# Access Compliance Report Public Rights-of-Way (Curb Ramps)

Main Street: O\_NEILL\_DR Cross Street: DORRANCE\_DR Location: S

ADA ID: RPRK211102130707 Ramp Type: Type 4 - Parallel Initial Pass/Fail: Pass Overall Compliance: No Severity Score: 15

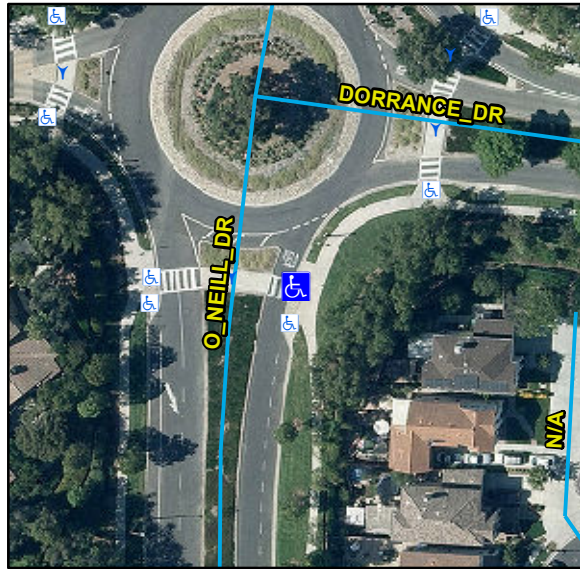
R304.2.1, R305, R304.5.4, R304.5.3, STD 1115

| Compliance | Description                   | Data       | Compliance | Description                   | Data  |
|------------|-------------------------------|------------|------------|-------------------------------|-------|
| N/A        | Landing Present               | Yes        | No         | DWS Provided                  | No    |
| No         | Gutter Run Slope (%)          | 6.7        |            | Road Cross Slope (%)          | N/A   |
| No         | Gutter Cross Slope (%)        | 4.6        | Yes        | Perpendicular Joint Present   | Yes   |

Remove & Replace Entire Ramp. Remove & Replace Gutter.
